From: [Whittaker, Roberta \(EXT\)](#)
To: [Matthew Wilson](#)
Cc: [Curley, Jane](#); [Planning \(SMDC\)](#)
Subject: RE: SMD/2021/0441 - Compton Mill - LLFA Acceptable with Conditions
Date: 27 April 2022 17:00:05
Attachments: [image002.png](#)
[image003.png](#)
[image004.png](#)
[image005.png](#)
[image006.png](#)

Subject: SMD/2021/0441 - Compton Mill - LLFA Acceptable with Conditions

Thank you for reconsulting us on the FUL application SMD/2021/0441 – Compton Mill

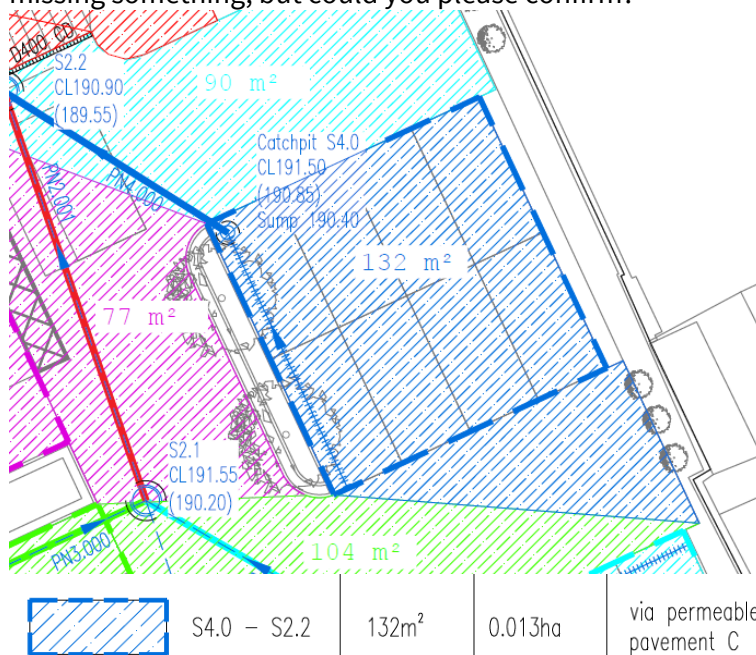
Sorry if I was unclear with this one. What I was referring to was the permeable paving itself. As you rightly state it shows as 132m² area in the plan but CP4 permeable paving is modelled in the MicroDrainage as 10x10m i.e. 100m² as shown in the screenshot below from the MicroDrainage.

Just in terms of the requested pre-commencement condition, would you please be able to clarify with regards to the requirement for "Provision of MicroDrainage modelling to include the correct permeable paving area shown in the surfacing plan (NW151/01/09 (A) June 21) for CP4". I've looked back at the calcs and the plan and the figures appear correct to me – On drawing NW151/01/09 A there is 132m² of impermeable area draining to CP4.0 and this is reflected as 0.013ha in the MicroDrainage model (see extracts below). Apologies if I am missing something, but could you please confirm?

Thank you for clarifying, I can see that the whole area of 132m² on the plan has been accounted for elsewhere in the MicroDrainage as per your first screenshot so can't see any reason to remove this from the conditions.

Jane please take this as confirmation from Staffs LLFA that the statement below can be removed from Condition 2 as set out in our conditions

I think the issue here is that we're proposing to use the permeable surfacing of the car parking bays to drain the rest of the car park circulation area (which will have an impermeable surface) rather than using gullies. So there is 132m² of area draining via that particular permeable pavement structure, but the permeable pavement itself (and therefore the associated sub-base storage structure which is shown by the screenshot in your email) only

covers the 10m x 10m of the parking bays. i.e. I am still of the opinion that it is set up correctly.
